ST. LUCIE PLANT UNIT NO. 1

AMENDMENT TO FACILITY OPERATING LICENSE

Amendment No. 13
License No. DPR-67

SUPPORTING AMENDMENT NO. 13 TO LICENSE NO. DPR-67

Figure 3.2-1 Allowable Peak Linear Heat Rate vs Burnup

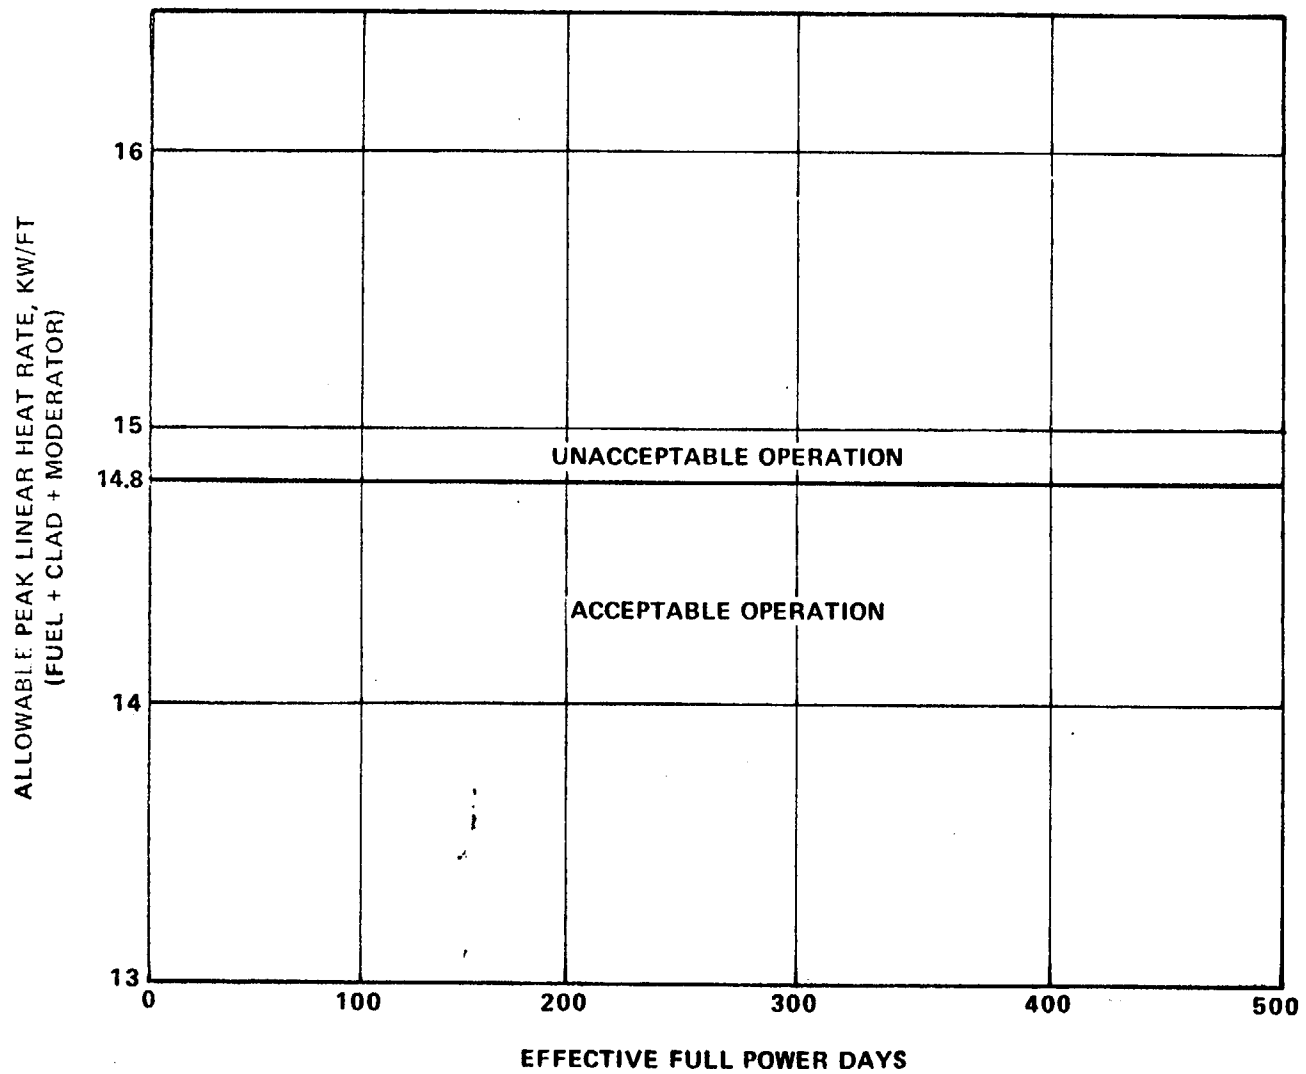
Corresponding to the results of the corrected ECCS calculations described above, the licensee submitted a proposed change to the St. Lucie Unit No. 1 Technical Specifications.⁽⁵⁾ The proposed change increases the allowable peak linear heat generation rate from the interim limit of 12.7 kW/ft to 14.8 kW/ft shown in Figure 3.2-1 on page 3/4 2-3 of the Technical Specifications.

Based on our review of the corrected ECCS calculations, we conclude that the proposed Technical Specification modification is acceptable.
